SUBJECT: Potential Manufacturing Problem With Certain Limit Switch Assemblies Used in  
ASCO General Controls Hydramotor<sup>®</sup> Actuators.

**POTENTIAL MANUFACTURING PROBLEMS WITH  
LIMIT SWITCH ASSEMBLIES USED IN ASCO GENERAL CONTROLS  
HYDRAMOTOR® ACTUATORS**

Limit Switch  
Assembly

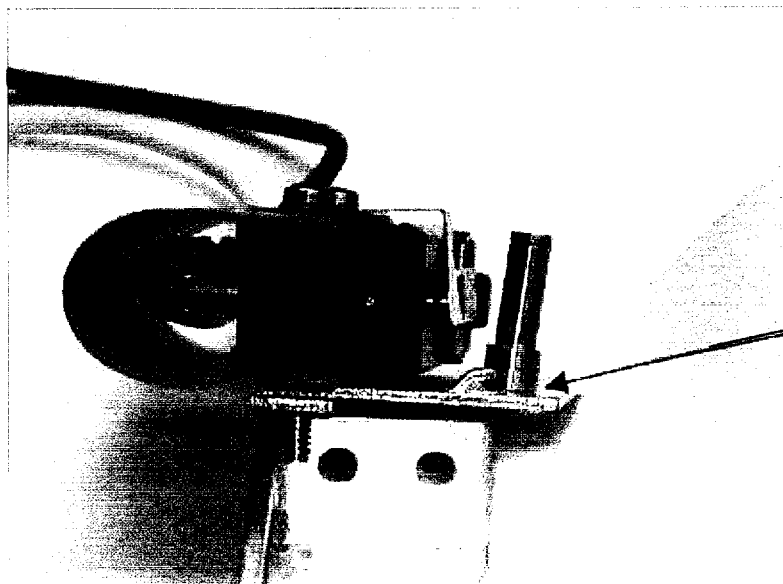
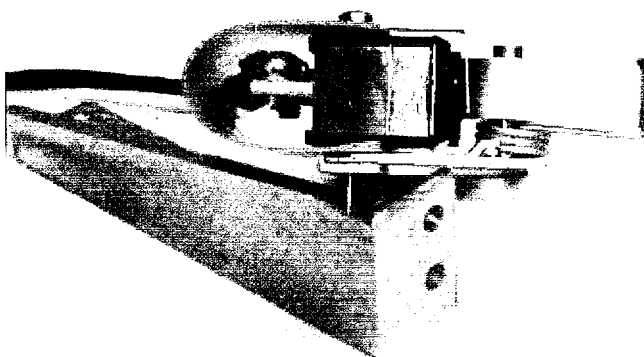
Analysis of the returned Limit Switch Assembly (see attachment 1) revealed that the shaft on which the position sensing lever operates was not secured tightly to the plate, causing wobble of the shaft. This wobble may result in the rotation of the lever past its actuation point, which would leave the switch contacts in the normally open (N.O.) position. This condition will result in the failure of the actuator piston to retract when the Hydramotor® is powered. The shaft is staked to the plate assembly. Manufacturing instructions for this assembly defines the maximum pressure to be applied for the staking press, but no minimum value. This led to variation of the staking process, which resulted in inconsistent and incomplete attachment of the shaft to the plate. (See attachment 2). In addition to the field return, Asco has found several limit switch assemblies in our inventory with this condition.

POINT OF  
FAILURE

VIEW SHOWING ANGULATION CONDITION  
OF FAILED SHAFT JOINT

ASCO will notify all purchasers of affected product of the potential problem. If the affected product is not in service, ASCO will offer to rework it at our factory at no charge. If the product is in service, ASCO will offer retrofit kits at no charge with complete instructions for installation of new limit switch assemblies. The method of forming this staked joint is being revised to ensure complete and consistent assembly of the shaft to the plate. In addition, the manufacturing instructions are being revised to fully define the parameters of this process as well as the testing necessary to confirm the reliability of the shaft-to-plate joining process.

VIEW SHOWING LIMIT SWITCH ASSEMBLY  
WITH PROPERLY SWAGED SHAFT
